Access Compliance Report

Public Rights-of-Way

(Pedestrian Signals)

Intersection ID: N/A	Main Street:	Cross Street: N/A	Location: N/A
ADA ID: 86A9125A0E58	Signal Type: Two Push Buttons-Non APS	Overall Compliance: No	Severity Score: BTN 1:N/A BTN 2: N/A No BTN: N/A
Codes/Mitigation Info/Possible Solution		Field Measurements/Component Compliance

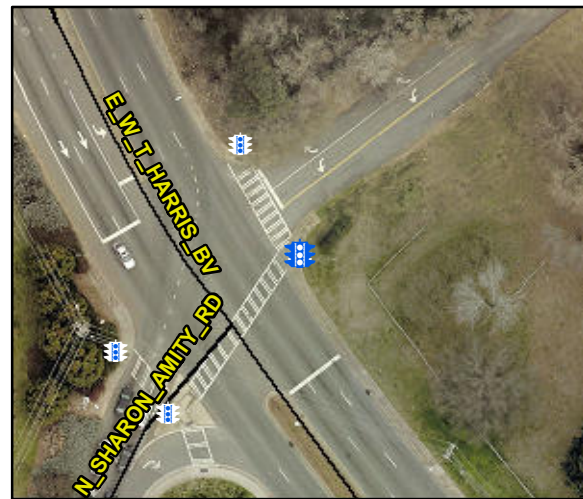
Surveyor Notes: TEXT HT 1/2

PROW/ADA: R410.6, TMUTCD 4e.08, R404.2, R404.3, R406.2, R209.1

Possible Solutions: Replace Signal Push Button With APS Button on New Post. Remove & Replace Sign.
